PCD APPROVED SITE PLAN
Any proposed changes to the approved site plan, such as but not limited to added hard surfaces, HVAC units, tree removals and accessory structures, must be submitted to the Building Department as a revision to the building permit for review and approval by all departments prior to implementation

SITE PLAN - LOT 9
ALEXA LANE
PARCEL # 1241500192
CITY OF KIRKLAND WASHINGTON

JOB NUMBER: 14-197
SHEET NAME: SP-01
SHT 1 OF 1

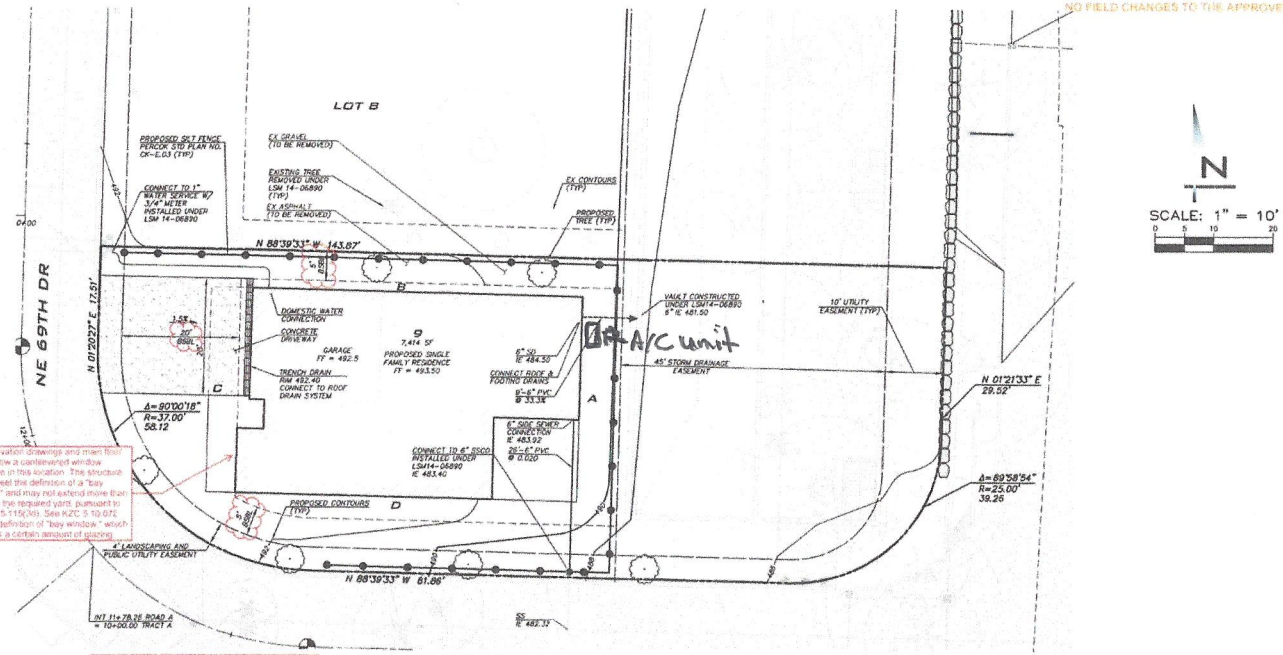
The elevation drawings and main floor plan show a cantilevered window structure in this location. The structure must meet the definition of a "bay window" and may not extend more than 18" into the required yard, pursuant to KZC 115.115(3)(b). See KZC 5.10.672 for the definition of "bay window" which requires a certain amount of spacing.
